Items 13c and 14a,
September 15, 2005:
Propose Amendments

**Re.: Coastal permit application for the replacement of the Greenwood Bridge,
Mendocino County, # 1-05-036 and A-1-MEN-04-036**

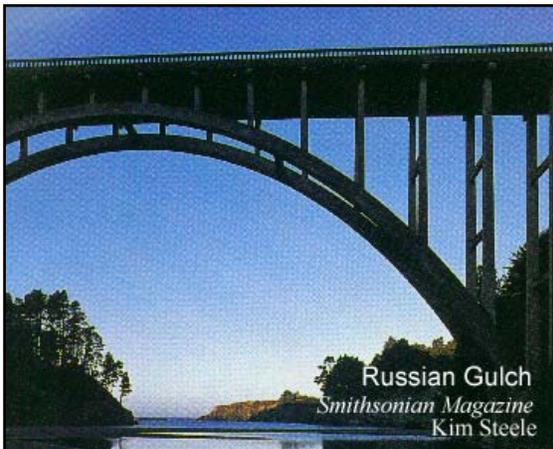
bridges of Highway 1. They would provide a link to the historic past. They would provide a feeling of tradition, as well as aesthetic beauty. Examples of such railings are shown below.

These railing are on bridges in France and are of cast iron. Alternative materials could be used, although cast iron would be structurally adequate for pedestrian railings.
